ADDENDUM NO. 1 TO ALL BIDDERS:

Reference – Invitation for Bid:	IFB #015-0-2025/SNB Yates Elementary School Security Vestibule and Office Addition & Alterations
For Delivery To:	Newport News Public Schools
Bids Due:	March 27, 2025 at 2:00 PM EST

## ADDENDUM NO. 1

#### Yates Elementary School Security Vestibule and Office Addition & Alterations

AD1.01

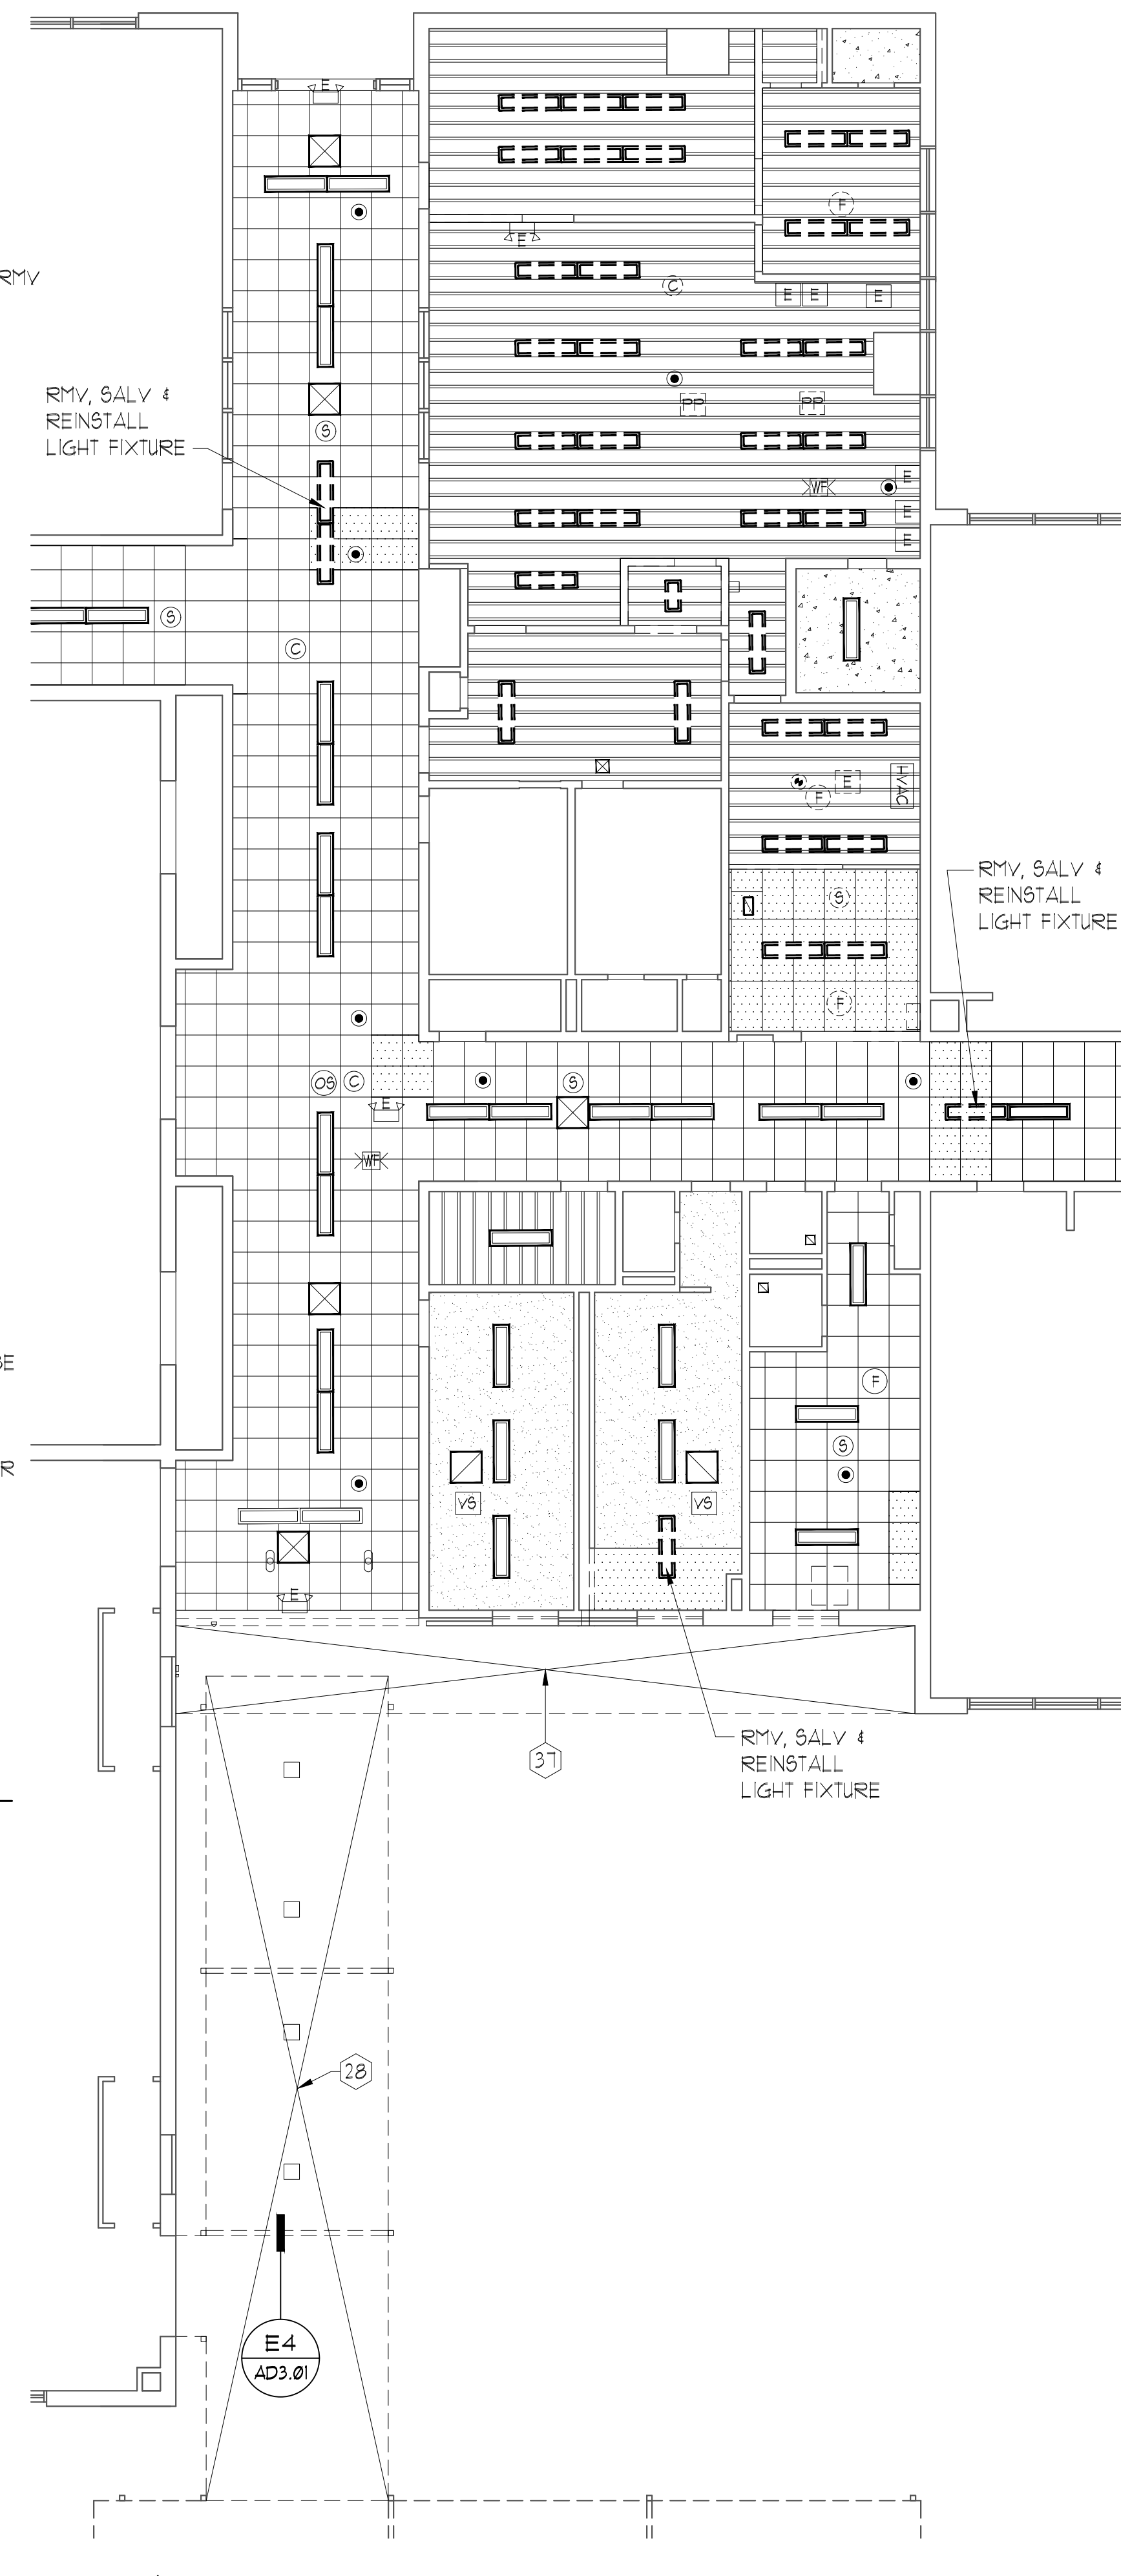
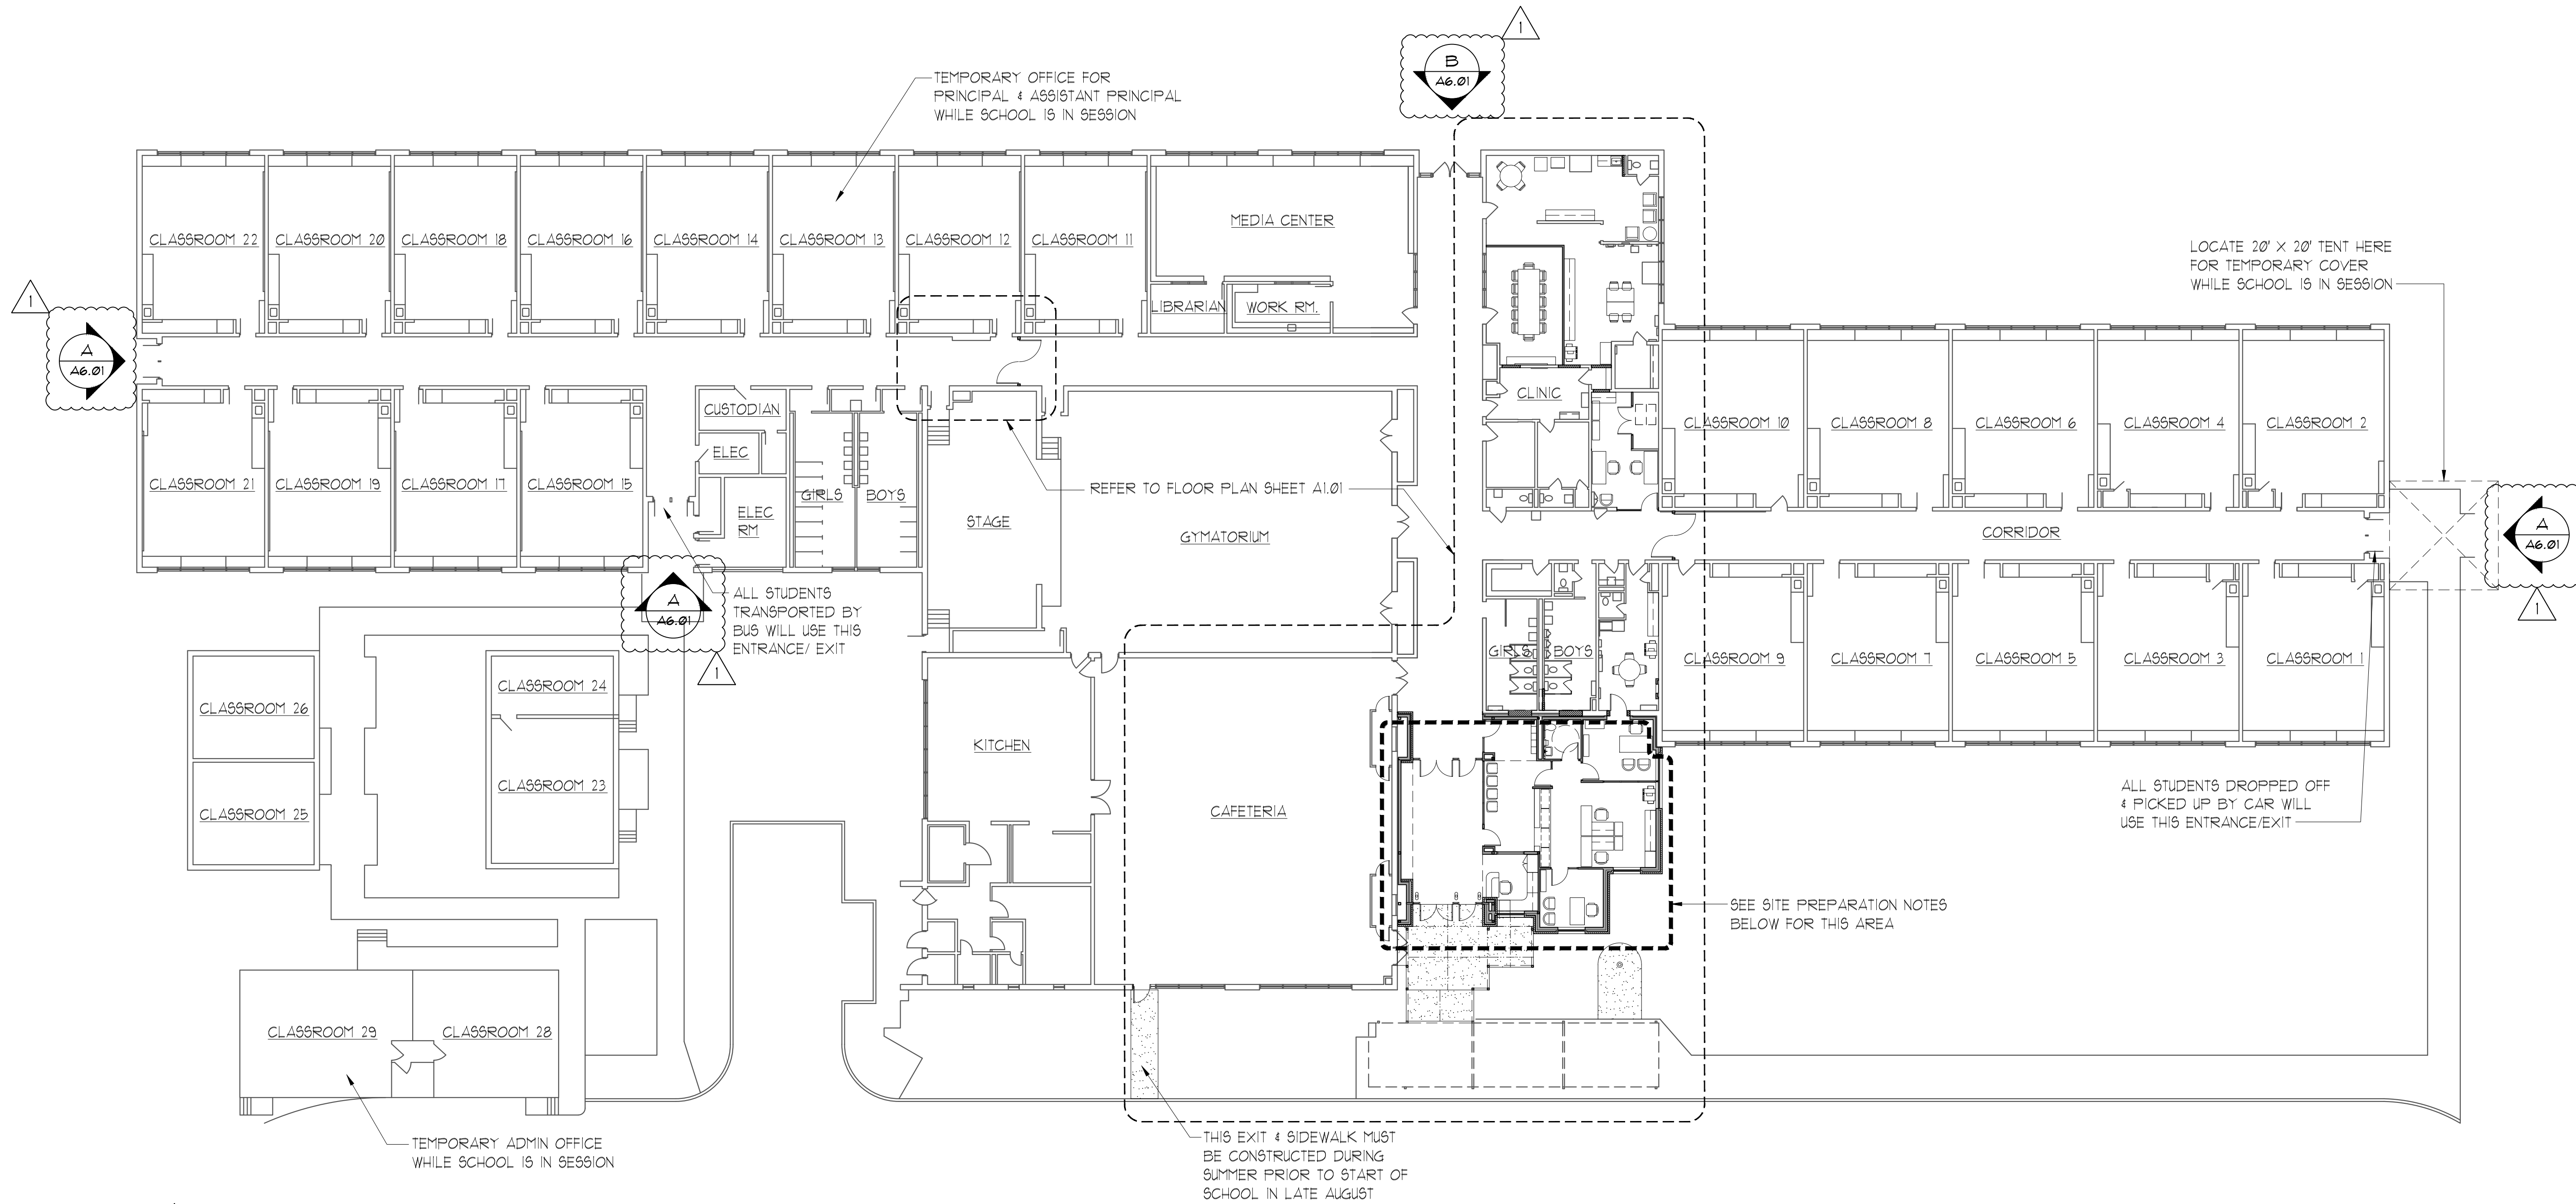
4. Architectural Drawing AD1.01: This drawing has been revised to include demolition of flooring and floor base finishes at an existing office next to the Clinic. New floor finish and wall base are scheduled elsewhere in the Addendum.
